Proposed Revisions to a Standard Plans Index

Index Number: 521-620

Index Title: Concrete Barrier/Raised Sidewalk - Wall Coping

TYPICAL SECTION THRU PRECAST COPING WITH C-I-P RAISED SIDEWALK AND RETAINING WALL AT EXPANSION JOINTS (32" Vertical Shape Shown, 42" Vertical Shape Similar)

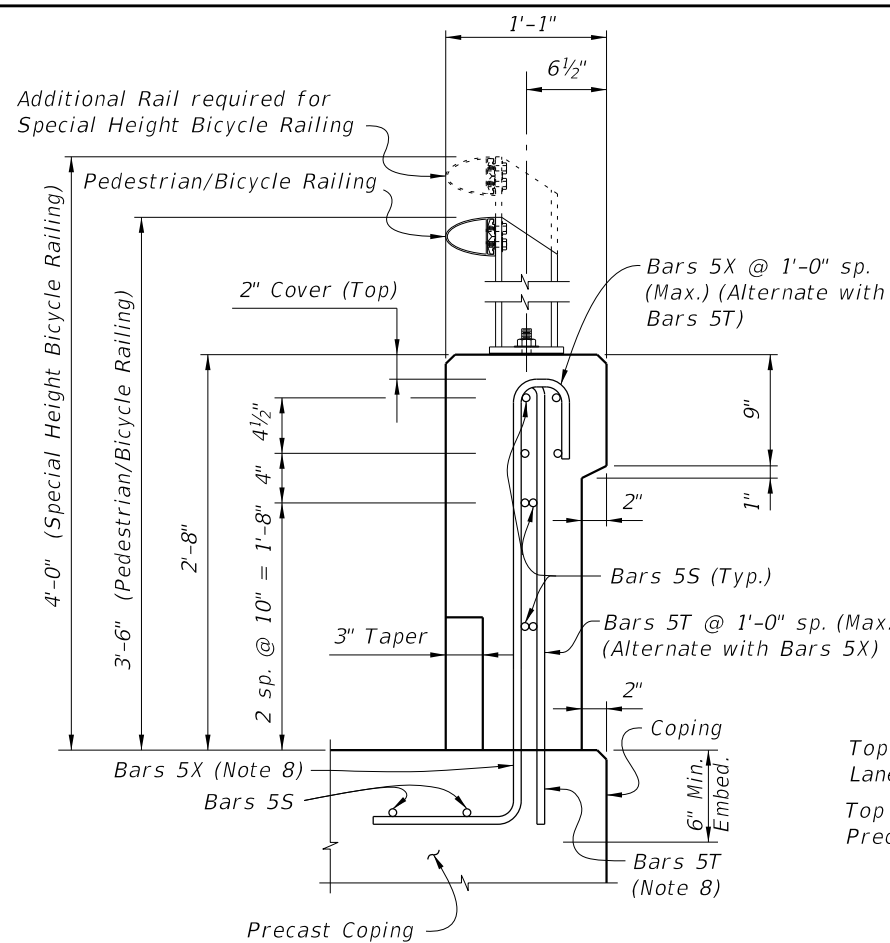
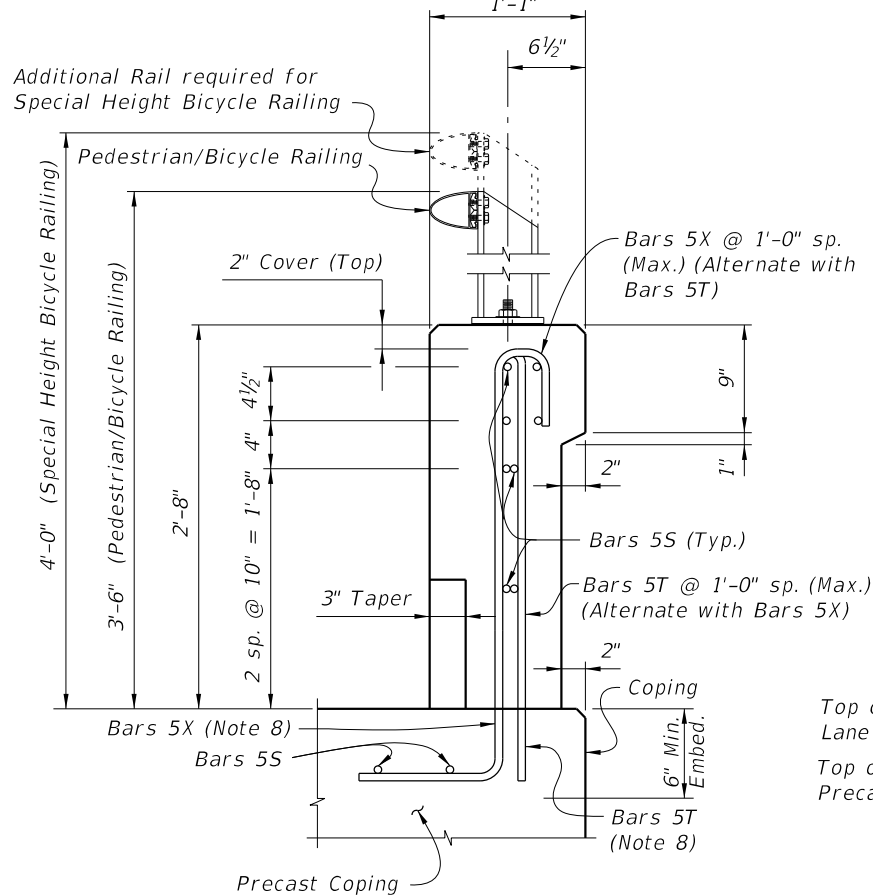
Changed C-I-P Buildup Concrete (1'-1" Max.) callout in the TYPICAL SECTION THRU PRECAST COPING WITH C-I-P RAISED SIDEWALK AND RETAINING WALL AT EXPANSION JOINTS to C-I-P Class NS Concrete (1'-1" Max.).

CHANGED TO: Class NS Concrete $\frac{1}{2}$ " Min. ~ 2 $\frac{1}{2}$ " Max. (Note 6)

CIP buildup concrete type was never clarified. SDO review deems Class NS is acceptable because the concrete buildup section is not meant to transfer any meaningful load to the wall other than self weight.
